October 26, 2020

**RE: PROPOSED DECOMMISSIONING LICENCE AMENDMENT - COMMENTS ON
CANADIAN NUCLEAR LABORATORIES LTD. (“CNL”) DECOMMISSIONING
LICENCE AMENDMENT APPLICATION FOR THE DOUGLAS POINT WASTE
FACILITY**

Decommissioning Douglas Point, Canada's First Full-Scale Nuclear Power Plant

Figure 1: Proposed new DPWF Decommissioning Timeline, reproduced from CNL’s webpage for Douglas Point [11]

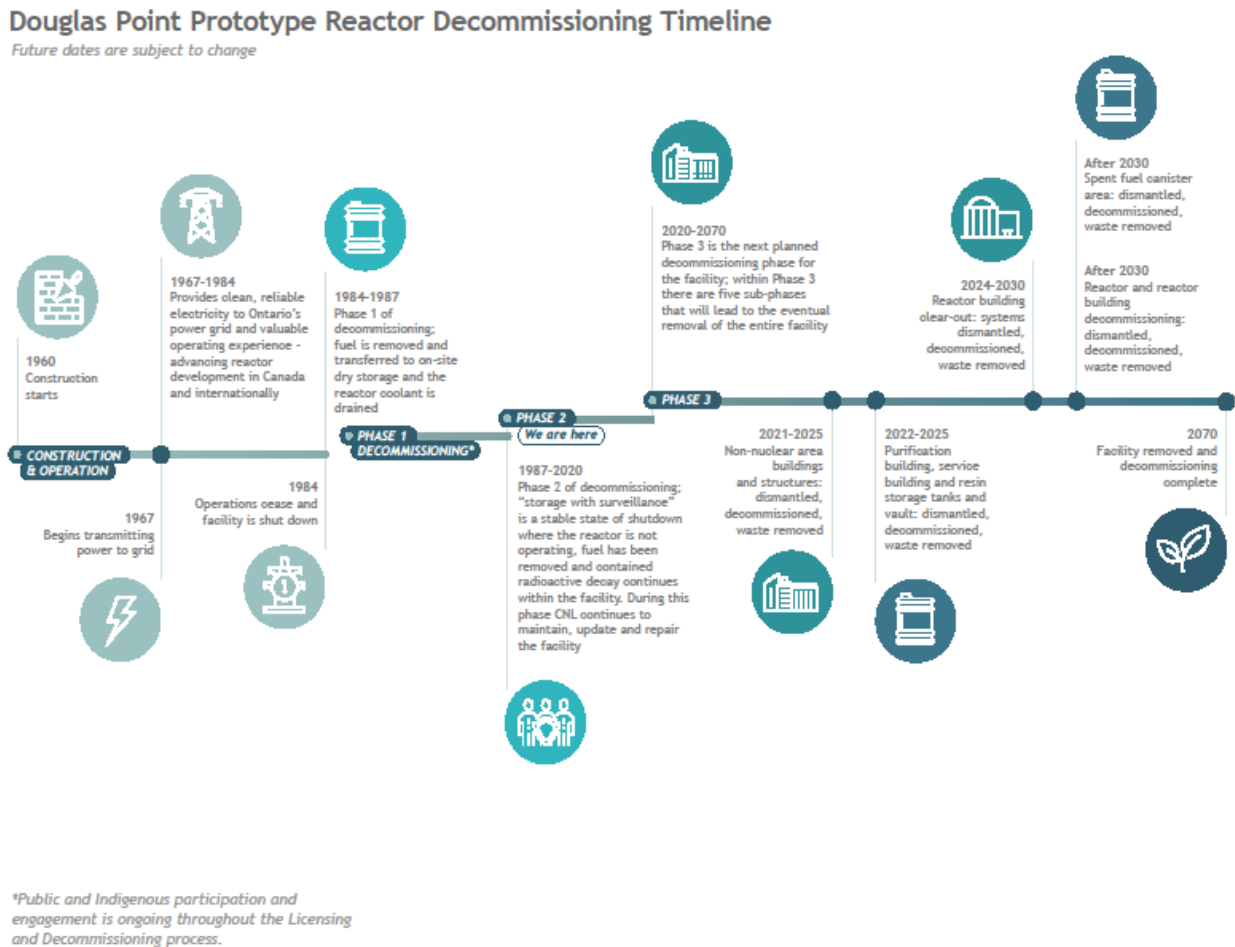
CNL’s proposed DPWF decommissioning timeline is depicted in **Figure 1** below. The timeline ends with the five proposed Phase3 decommissioning planning envelopes/sub-phases on the right.

CNSC’s Regulatory Guide G-219 (Decommissioning Planning for Licenced Activities), Sections 6 (“Structure and Content of Decommissioning Plans”) expects a detailed decommissioning plan (DDP) “normally to be a refinement and procedural “fleshing out” of the work package structure established in the PDP” [10]. DDP1, however, clearly marks a significant strategic departure from the PDP [emphasis is the author’s]. Although one would expect such an unusual departure of a DDP to be explained and justified carefully and in detail, it is remarkable that the DDP1 leaves most of the strategic points of departure unexplained, as will be seen in Section 5.
